Re: License No. SUA-708

**Tailings Stabilization
and Site Reclamation Plan
License No. SUA-1471
Docket No. 40-8903**

SITE RECLAMATION PLAN

REVISION
OF
FIG. 9

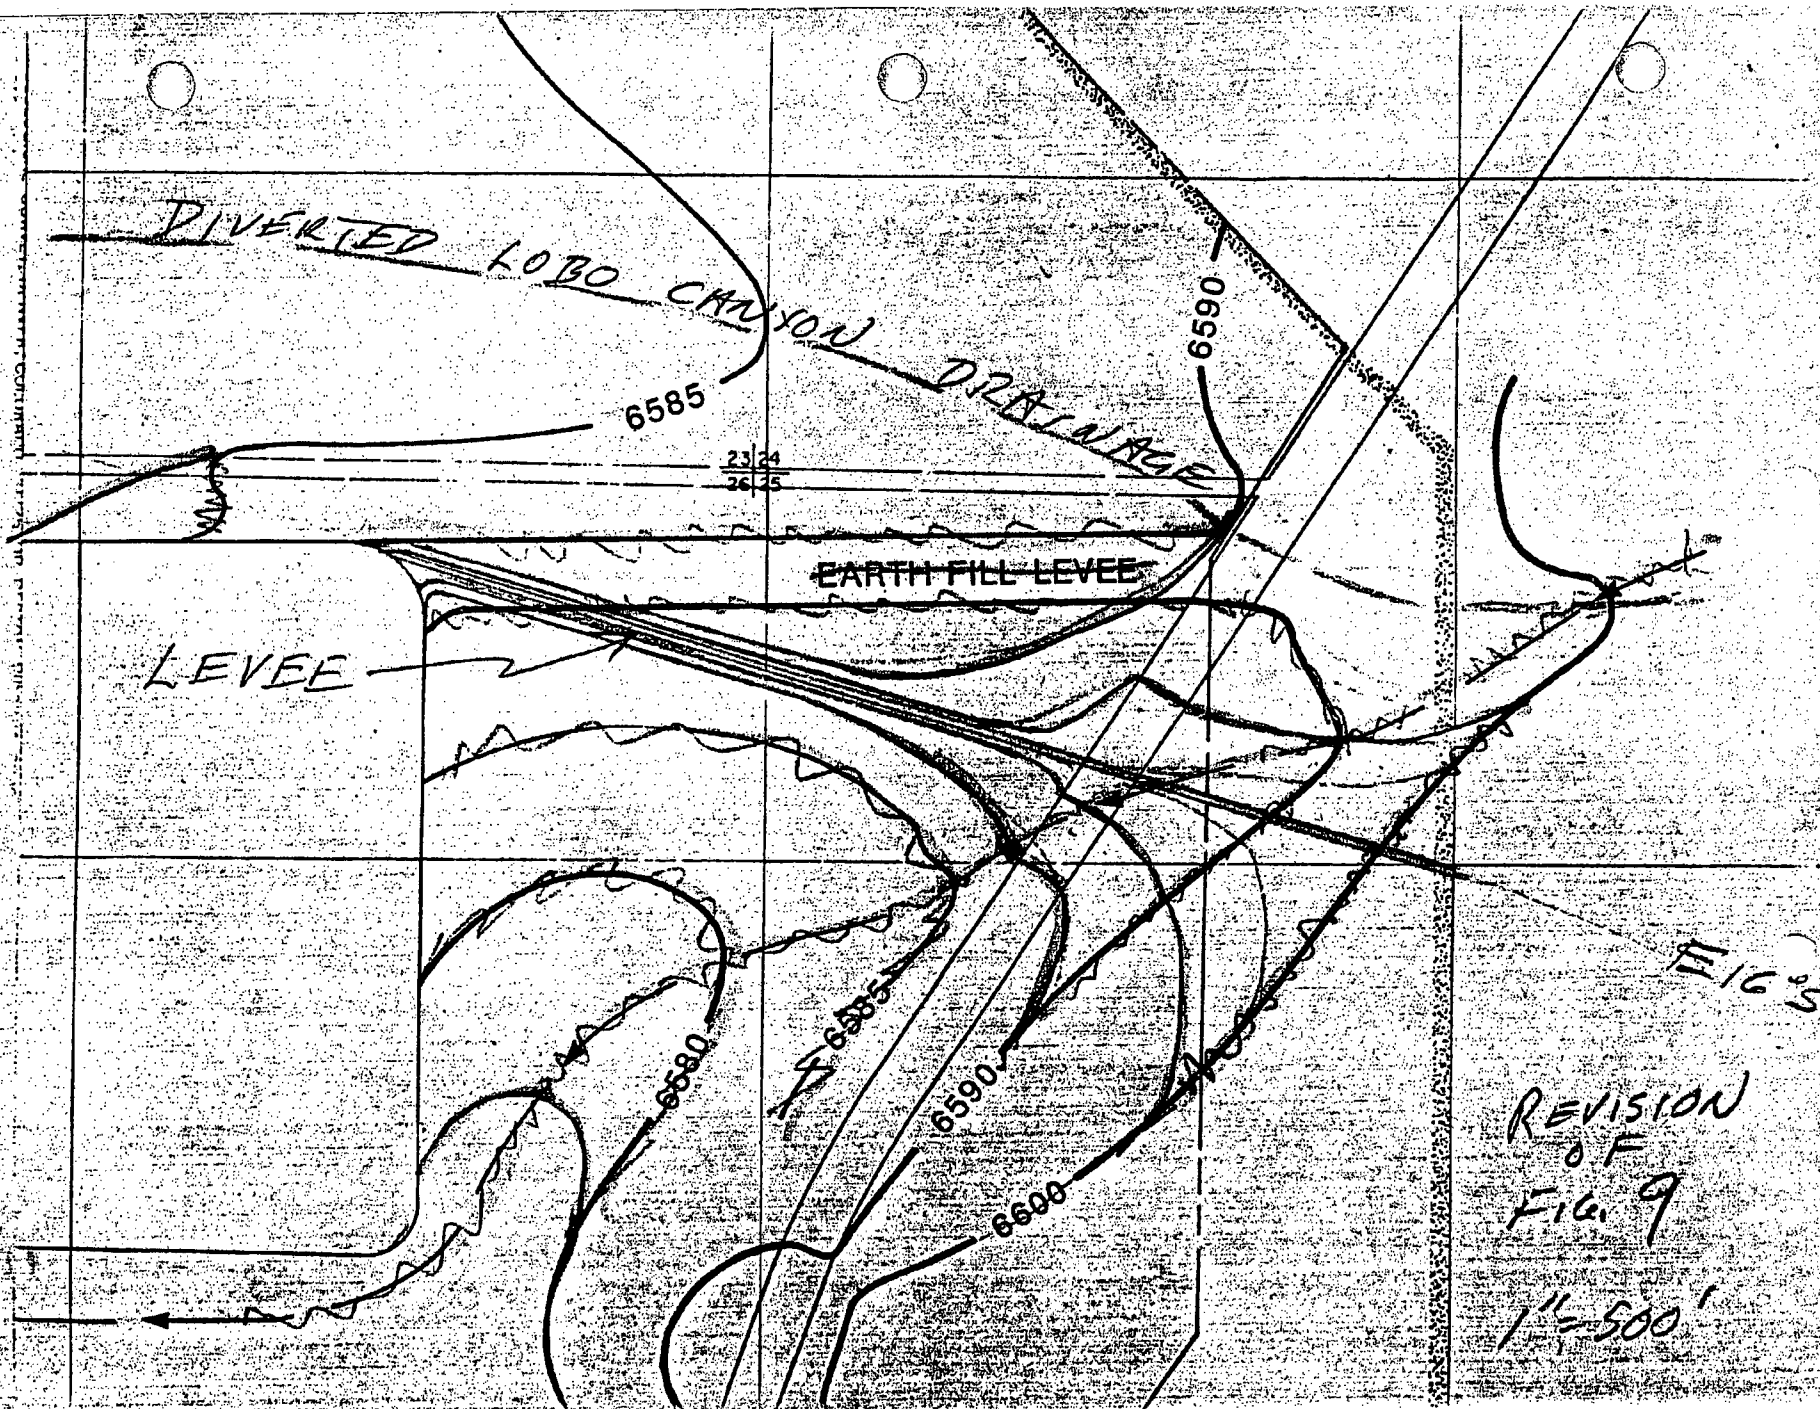
1.a. The levee at the northeast corner of the embankment has been realigned to run E 16 S to take better advantage of existing topography and to minimize or eliminate off-site cut and fill. The poorly defined course of the Lobo Canyon drainage will be rechannelized north of the impoundment. These changes are shown on the attached sketch of the Fig. 9 revision, in which pink highlights the scrub-outs, green the levee crest, and solid blue the revised contours. Figure 12 will also be revised to reflect these changes, as shown on the attached sheet. The flood routing will determine what crest elevation is needed, but at this time the levee is being designed for 3:1 (H:V) slopes and a 20 foot wide crest at elev. 6605. Fill will be sandy soil excavated for Lobo Canyon drainage rechannelization and compacted to at least 105 pcf dry density.

FIG. 12

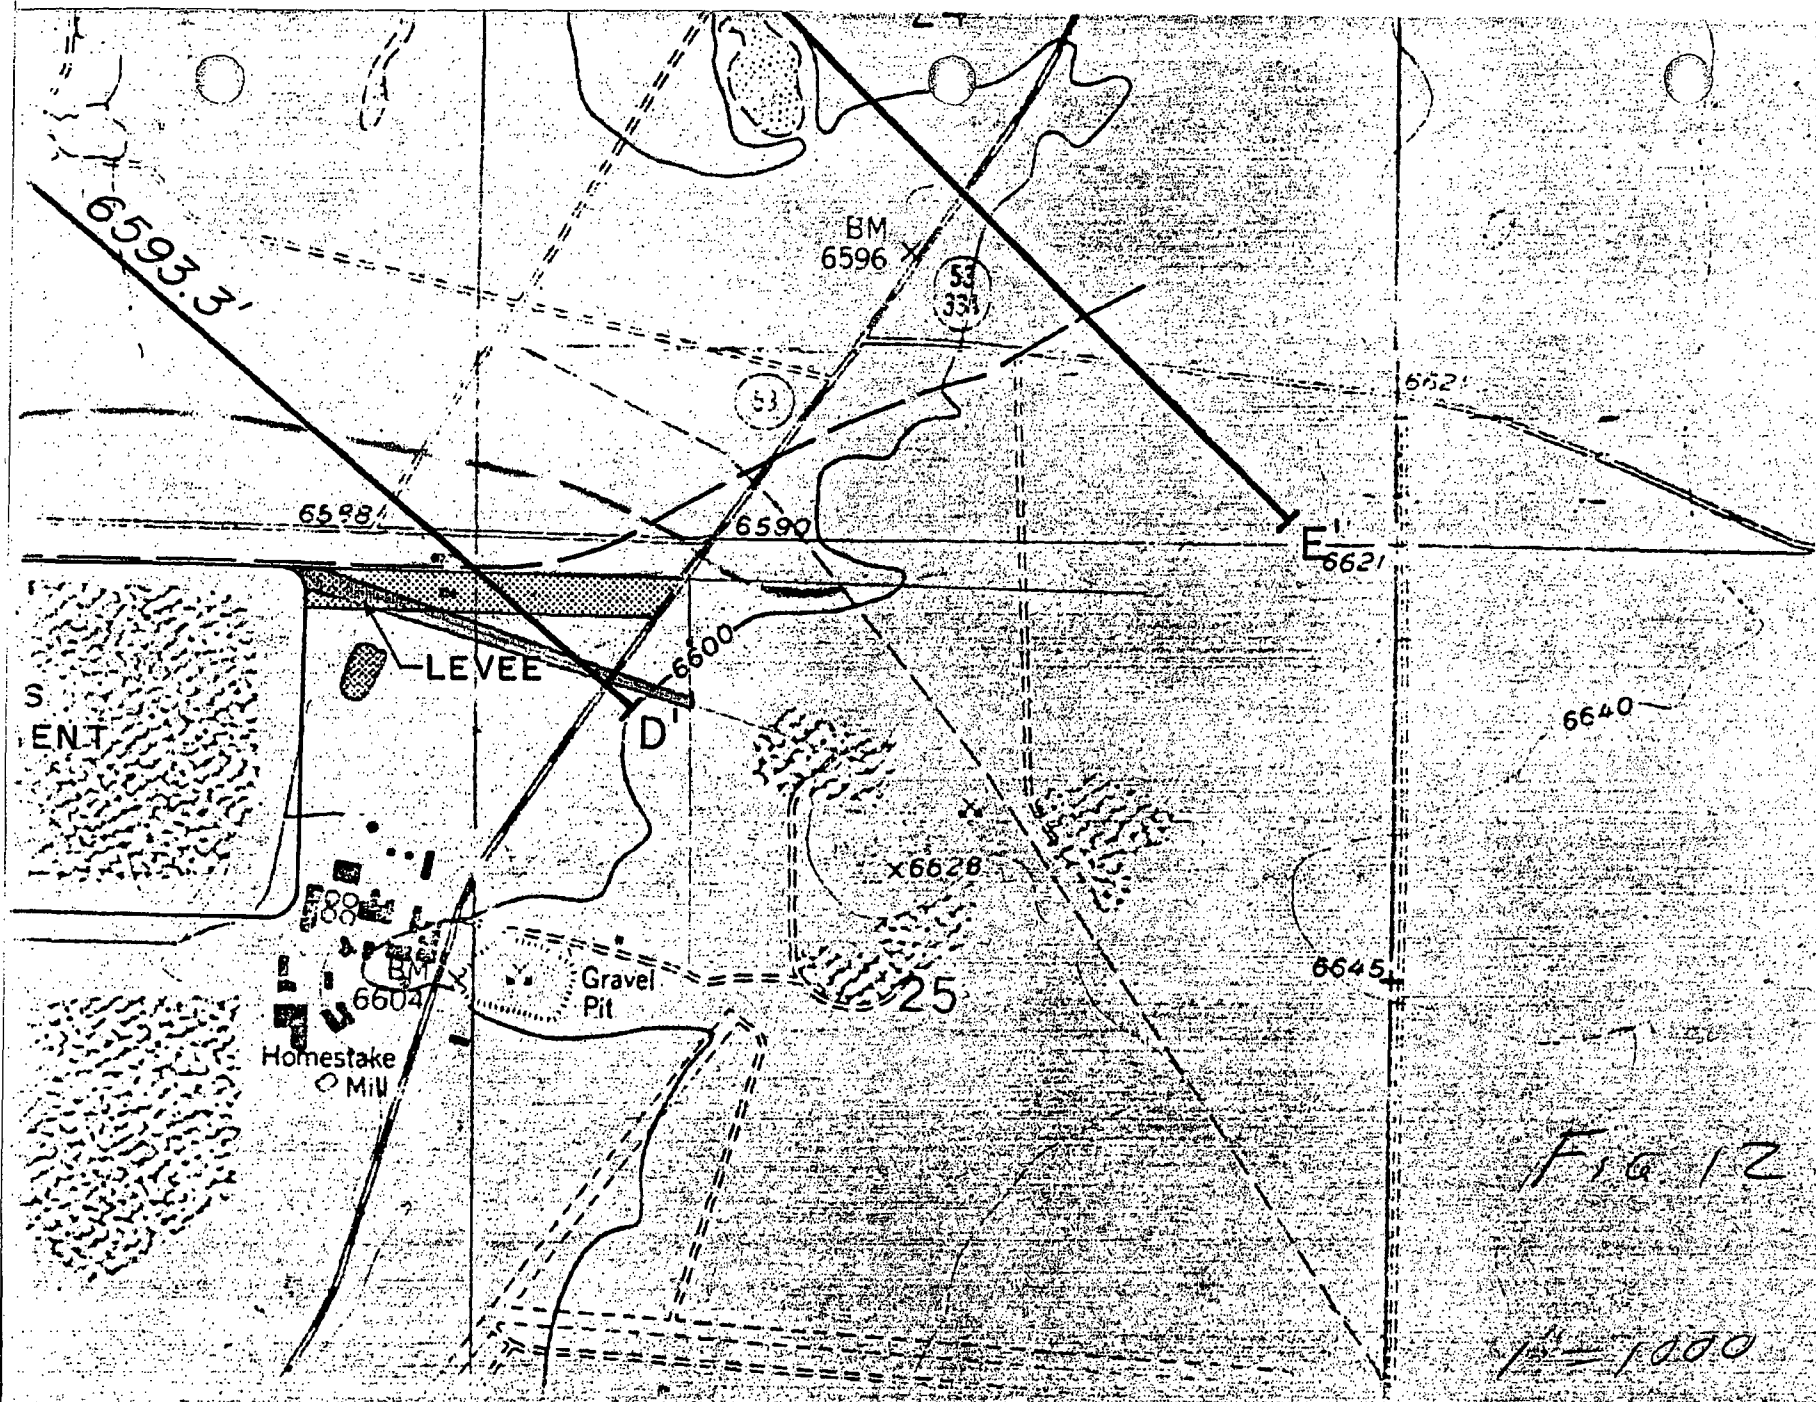
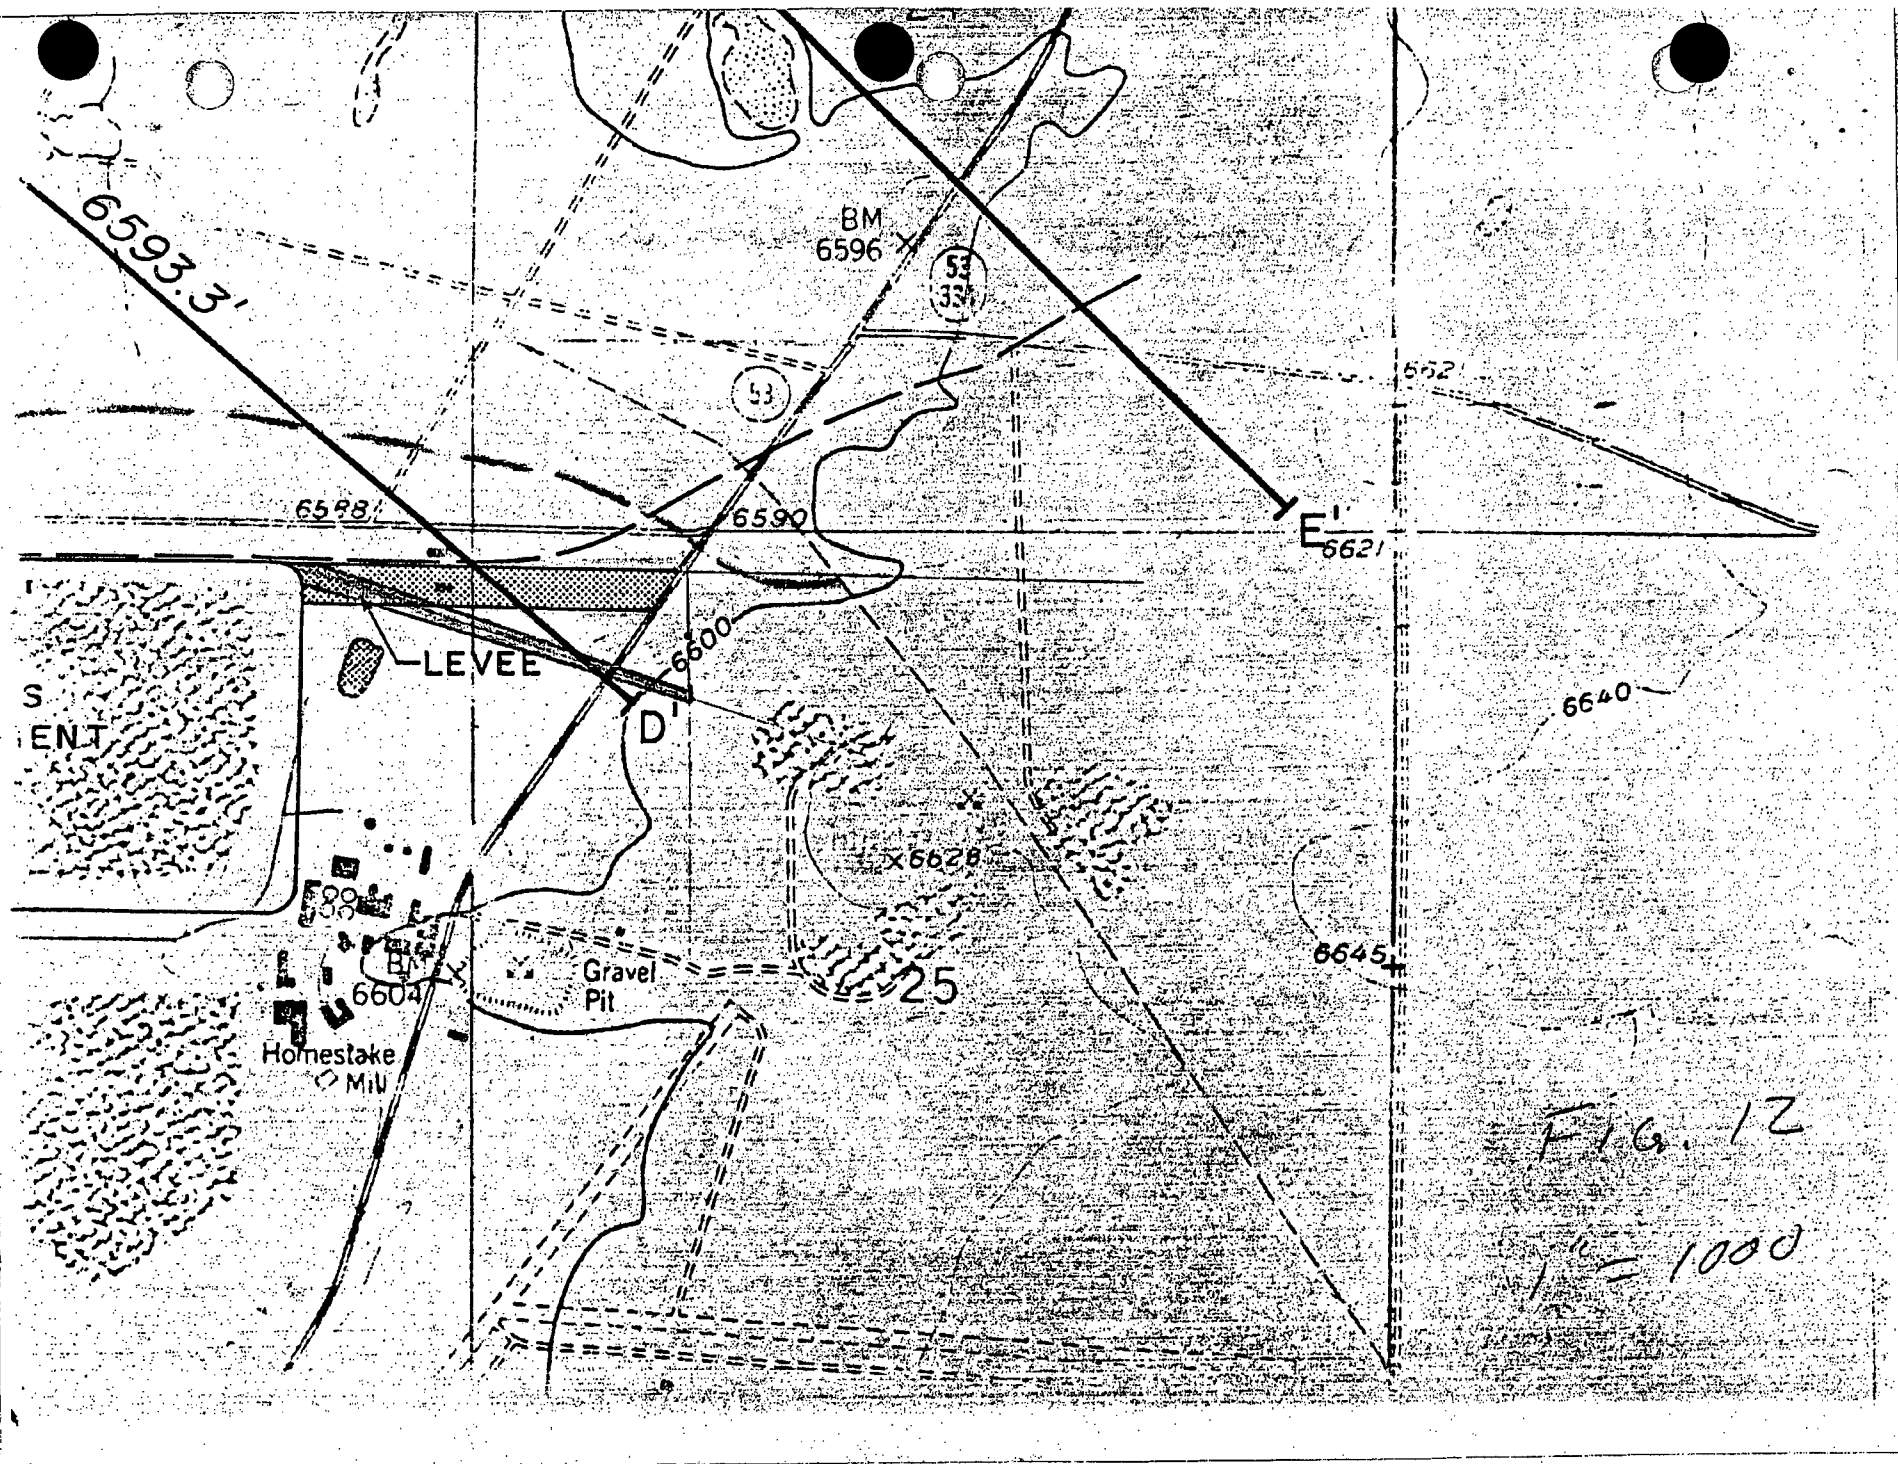
2. The attached letter explains the development of the cross sections used in the HEC-2 analyses. The topo maps used are listed and are available from the USGS in Denver.

"Sections Z-Z', A-A', and C-C' were developed from an enlargement of a composite map made from USGS 7.5-minute topographic map sheets of Bluewater, Dos Lomas, Milan, and Grants, New Mexico. This enlarged composite was used as the base map for Figures 8 and 12. Sections B-B', D-D', and E-E' were surveyed in either 1980 or 1981 by Homestake personnel using laser surveying equipment. The sections for B-B' and C-C' were modified to include the reclaimed borrow pit configuration as shown on Figures 8 and 9."
